## ENGINEERING SITE PLAN FOR EXCEL TELECOMMUNICATIONS SERVICE CENTER

**MEMORANDUM**

Date: January 2, 1996  
To: Lynn Chandler, Building official  
From: Stade Strickland, Director  
Subject: Excel Telecommunications, Inc.

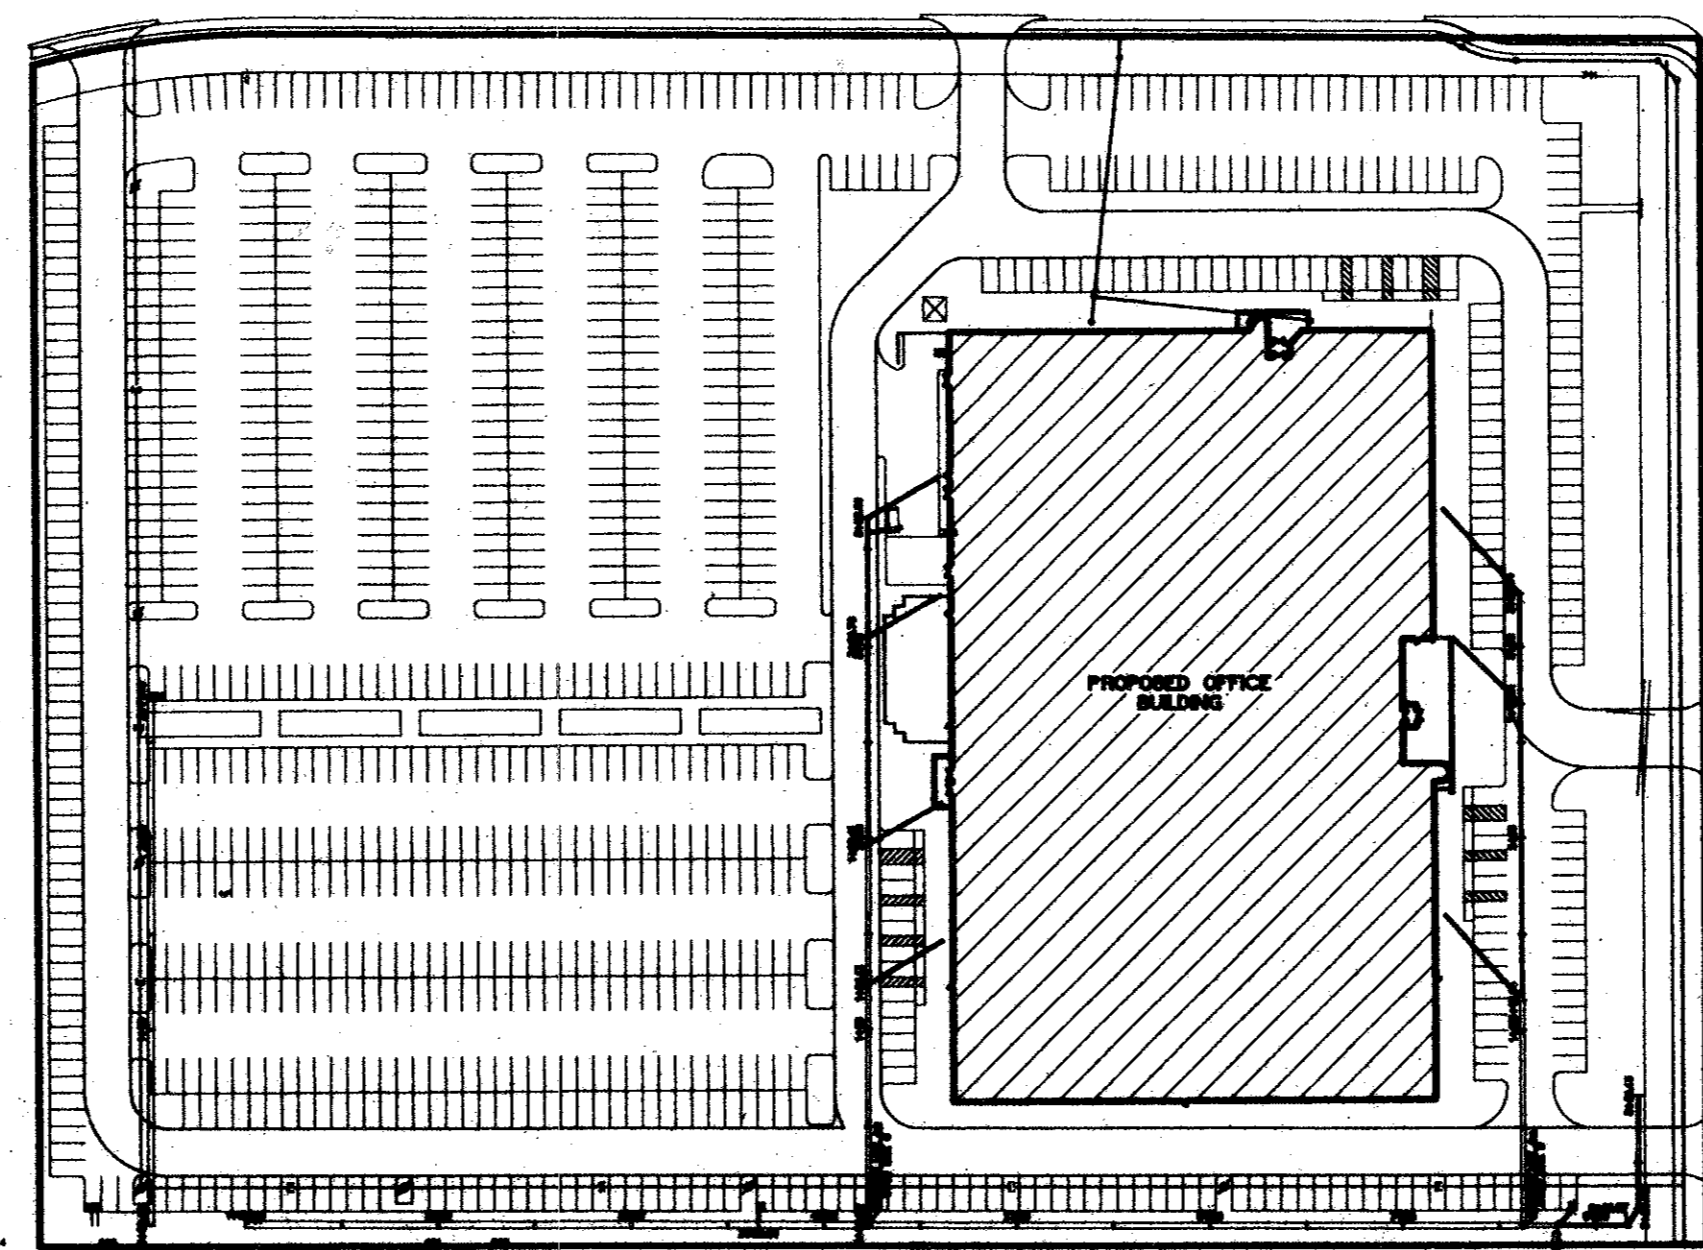
UPON COMPLETION OF PROJECT  
THE ARCHITECT MUST SUBMIT LETTER  
STATING BUILDING SITE MEET REQ.  
OF LIT 31.155143C.

Question Regarding Detention Area Along Addison Road - Much Larger than Preliminary Proposal - Move Detention to Rear of Property - Inappropriate Use as Landscape Buffer Along Addison Road.

**01 SITE PLAN - MEP**  
SCALE: 1" = 40'-0"

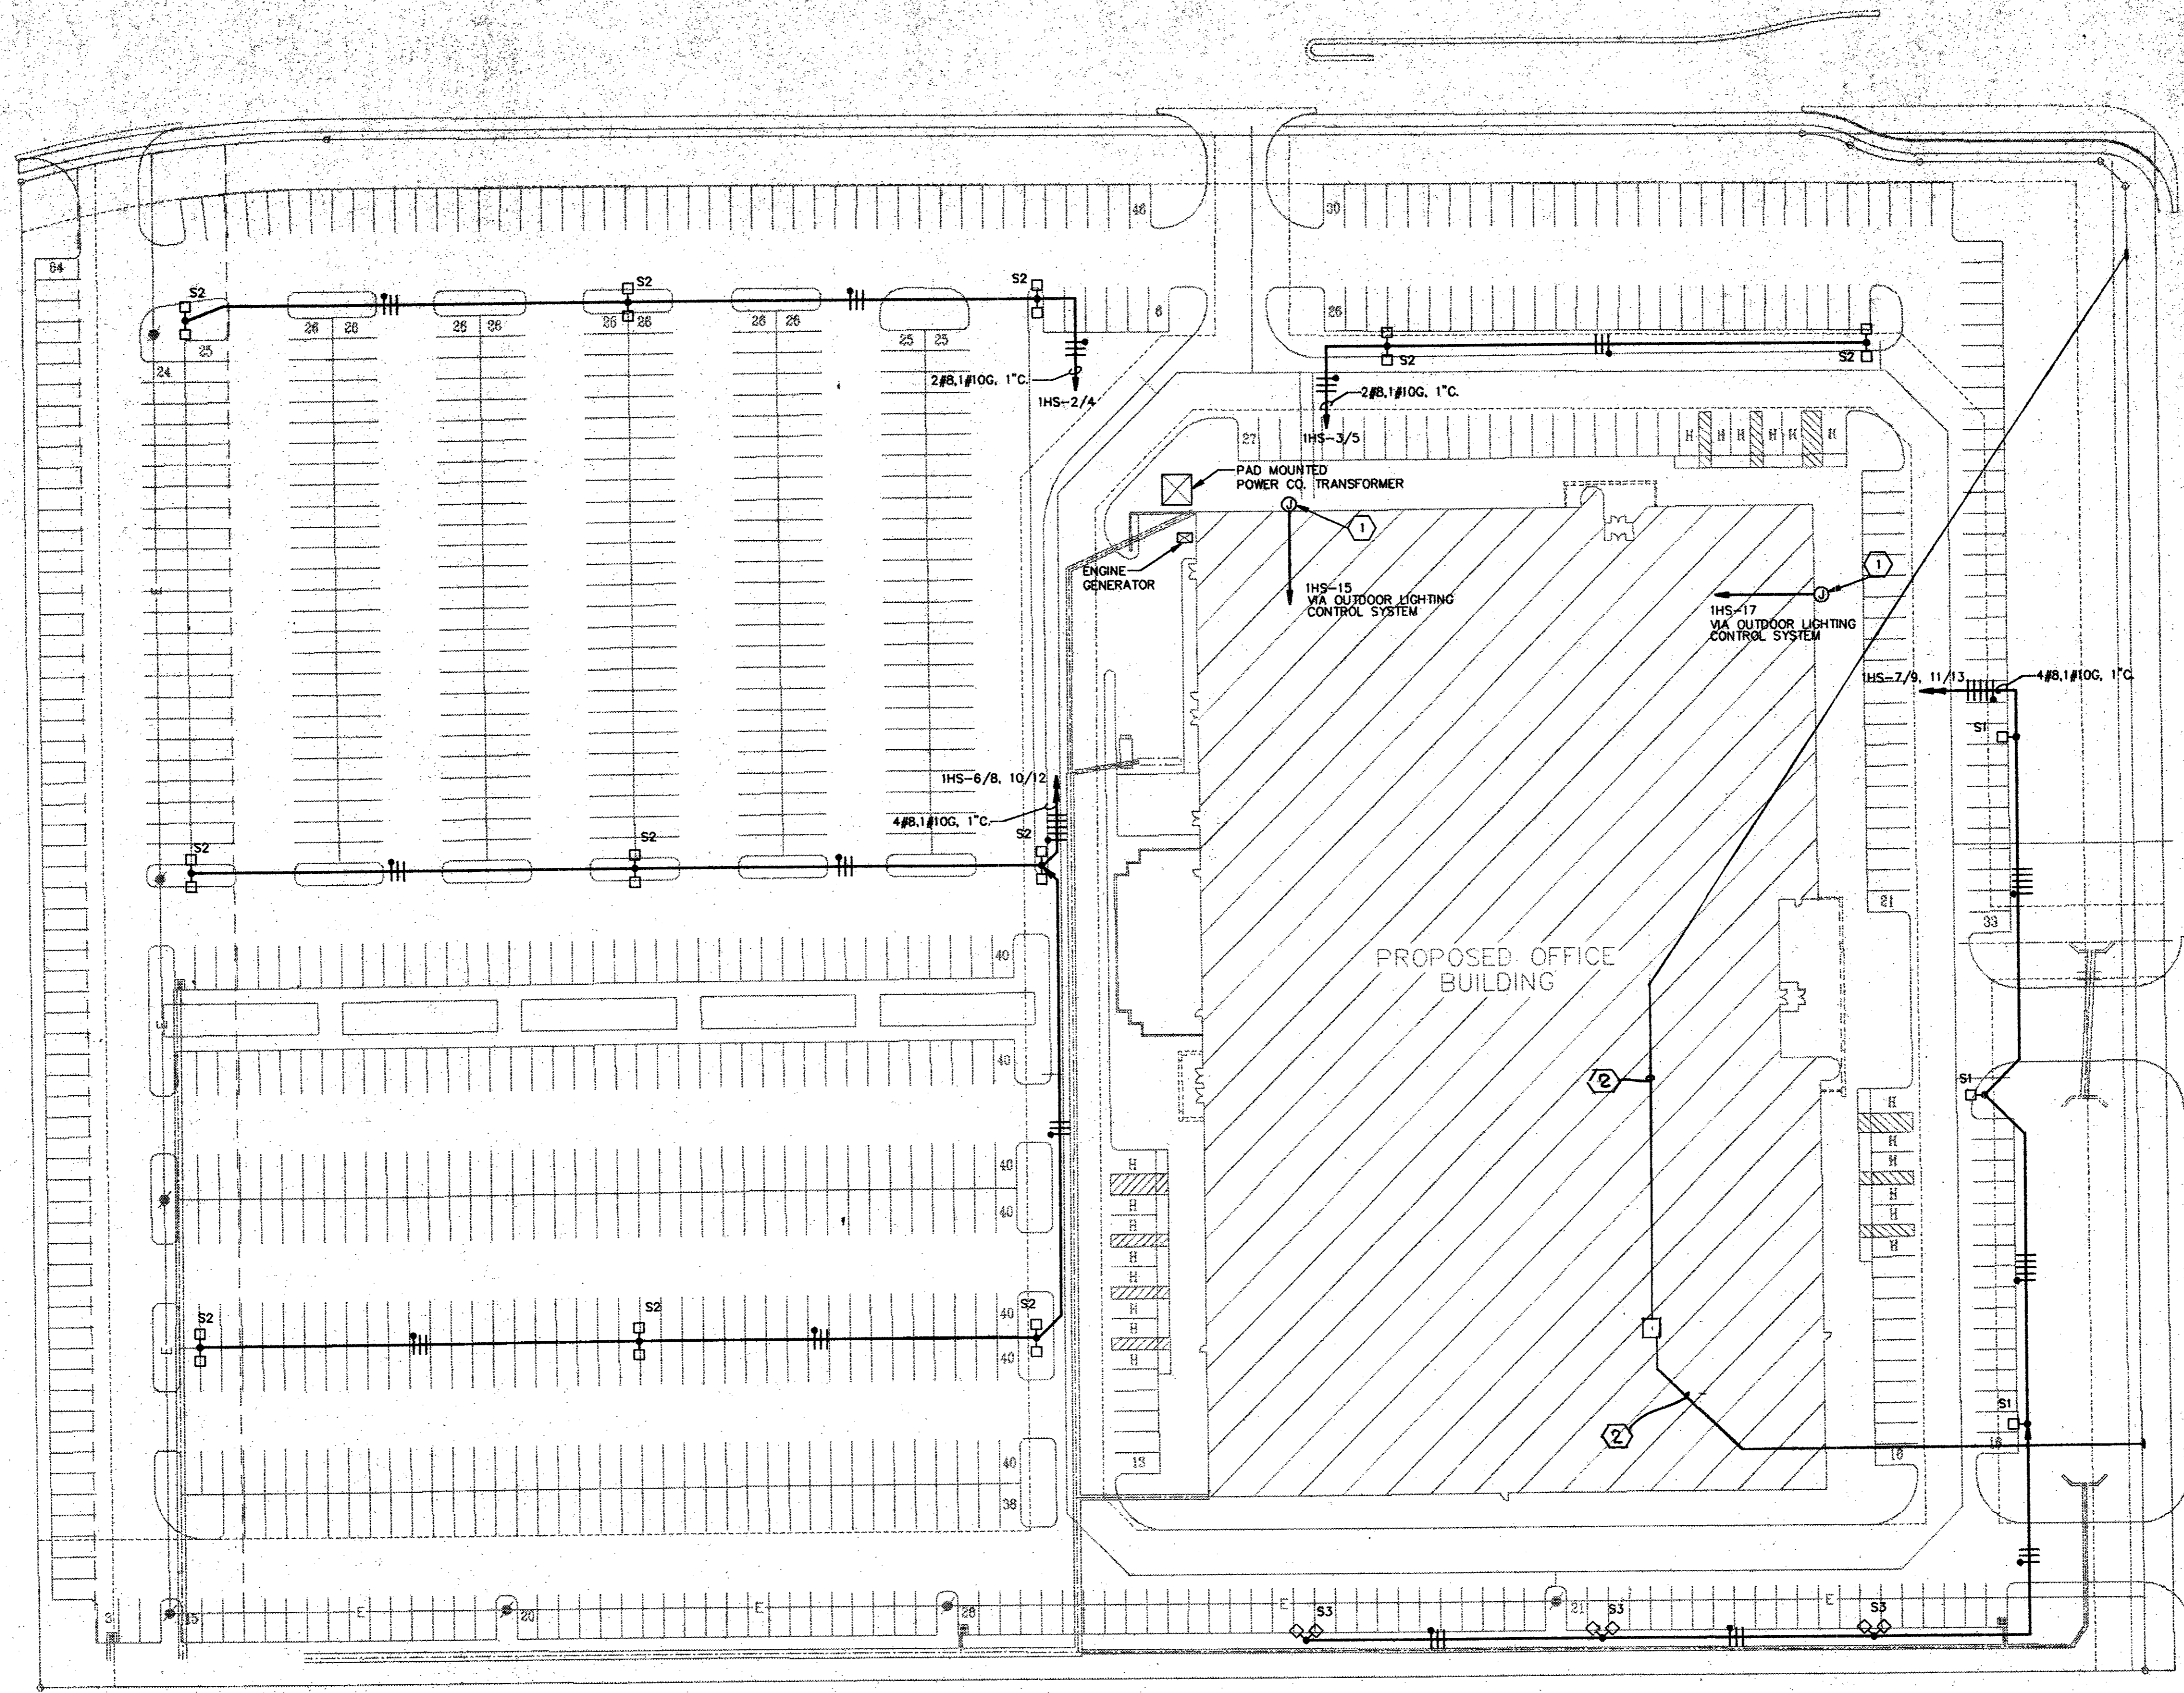
LIGHTING PLAN MUST BE APPROVED BY ADDISON PD  
CALL BOB McKITTRICK AT 450 7146

**SITE PLAN**

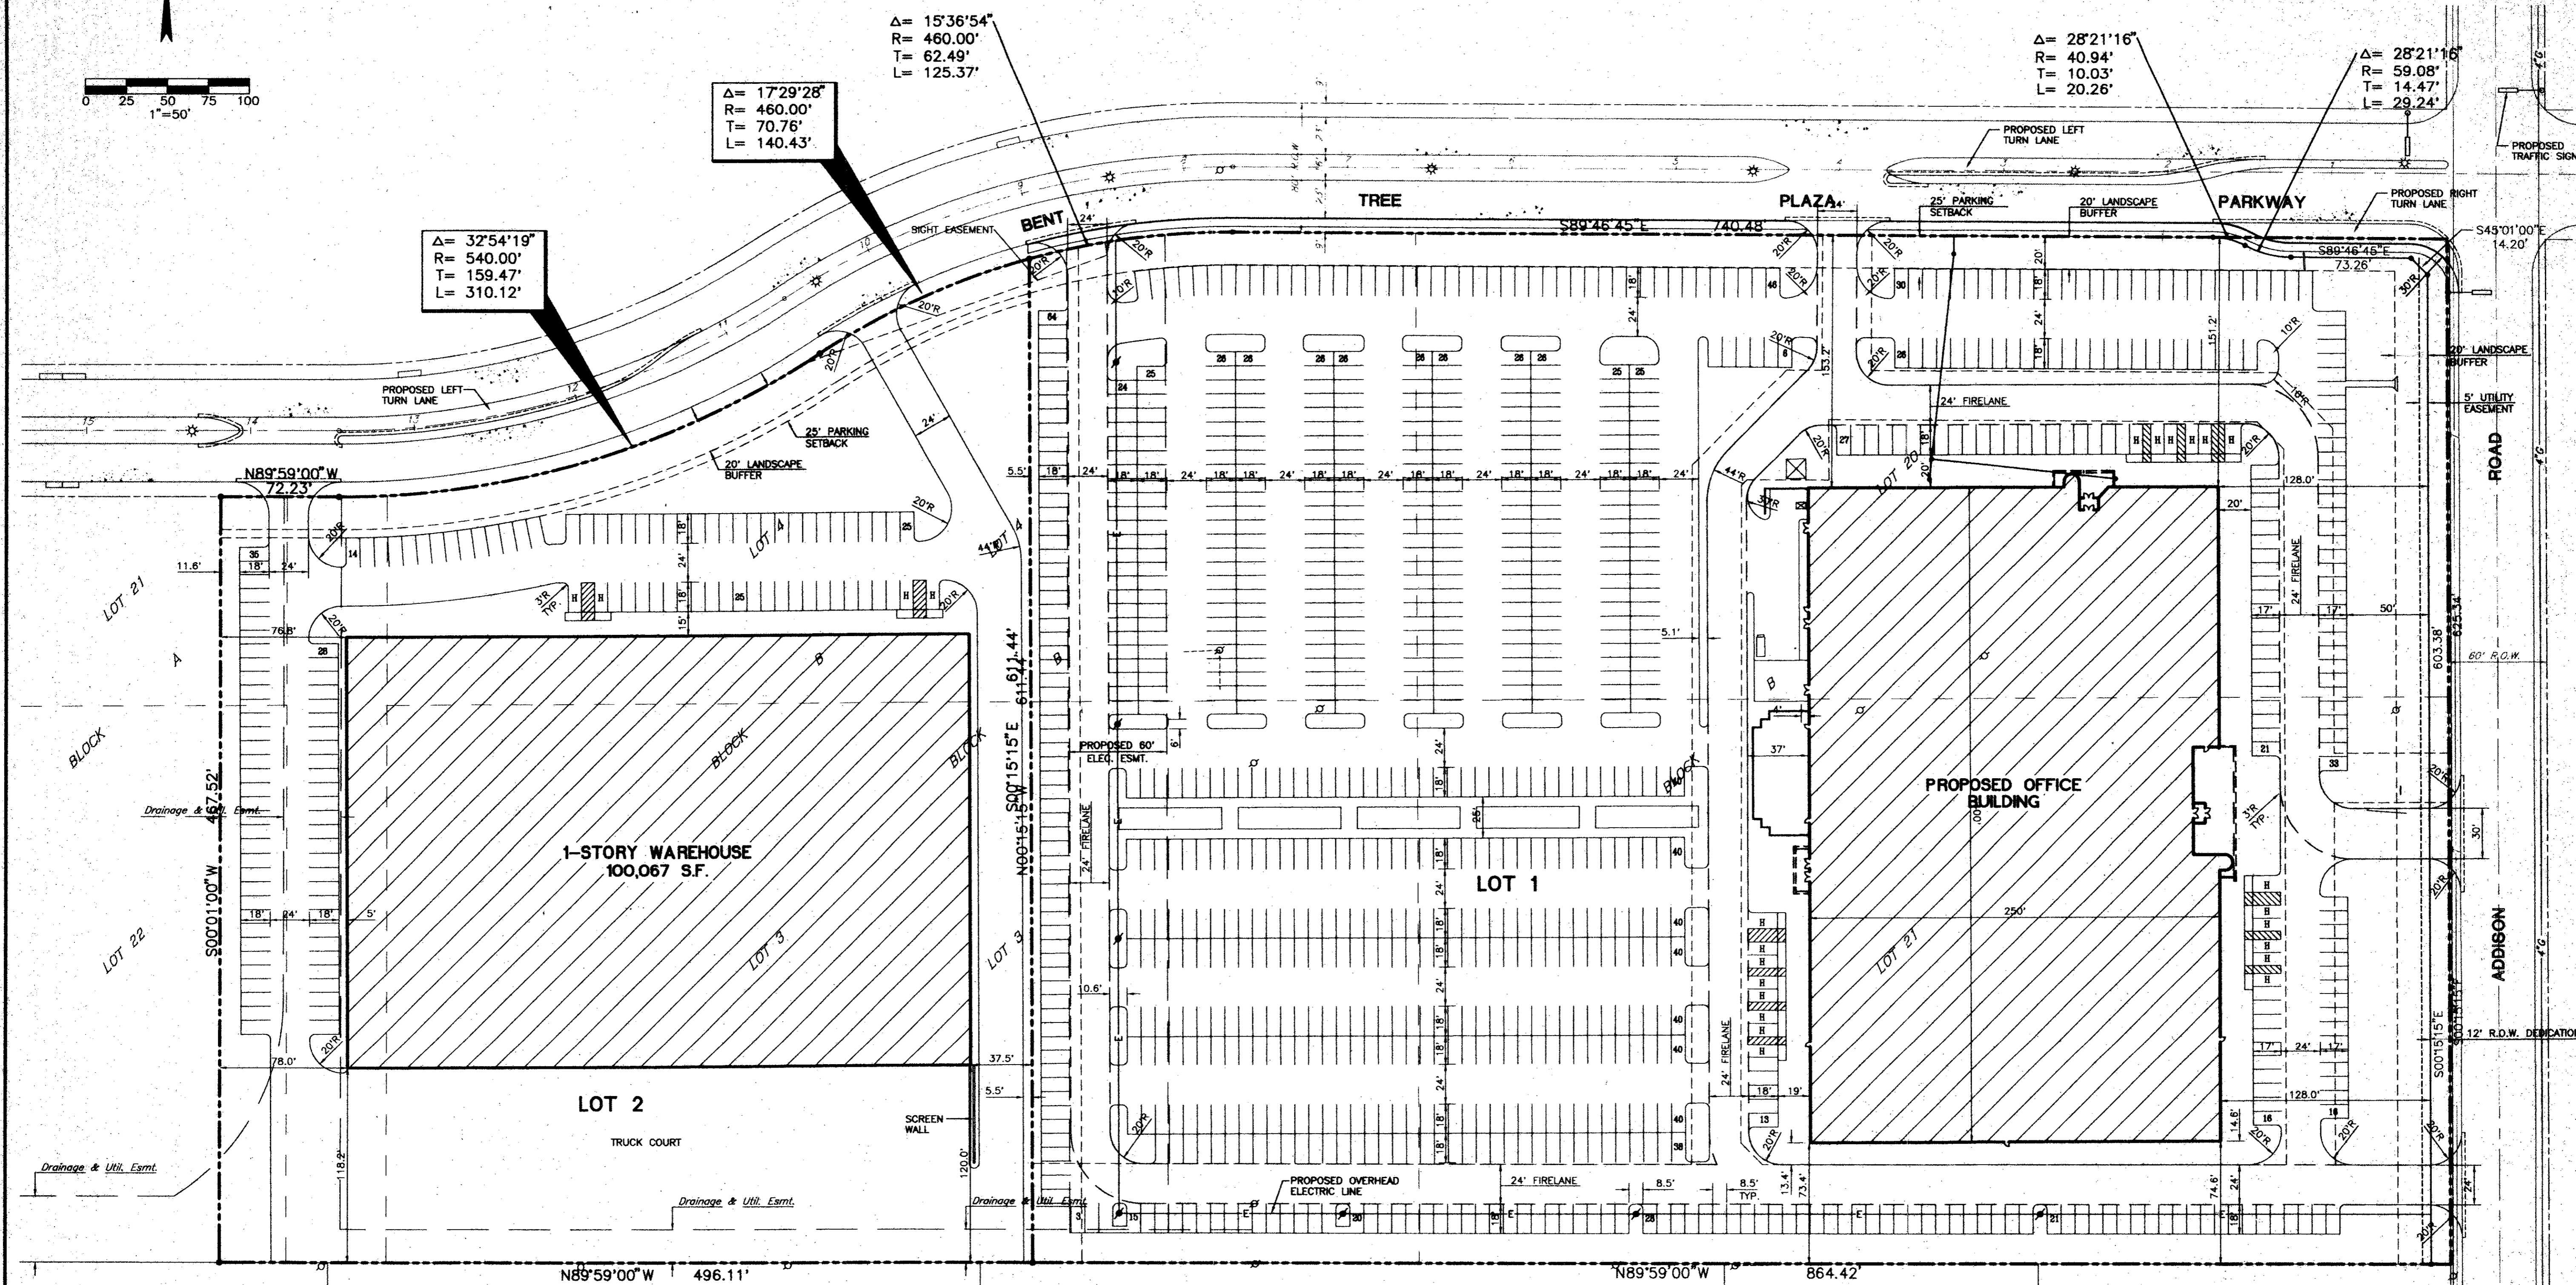
The following conditions need to be addressed on a revised landscape plan before final approval of a building permit:

- Specify which type of grass is proposed and whether it will be sodded or seeded. Sodding is preferable;
- Add 21 shade trees to comply with the number of trees required by the landscape ordinance;
- Move all shade trees outside of the dedicated roadway area along Addison Road;
- Show a 5 feet wide sidewalk along Addison Road.
- Show benning along Addison Road and Bent Tree Plaza Parkway

The detention area shown along Addison Road is inconsistent with the intent of the landscape ordinance because it provides no visual buffering of the building and the parking lot. It needs to be located to the south or west side of the site behind the building so it can't be seen from the street.
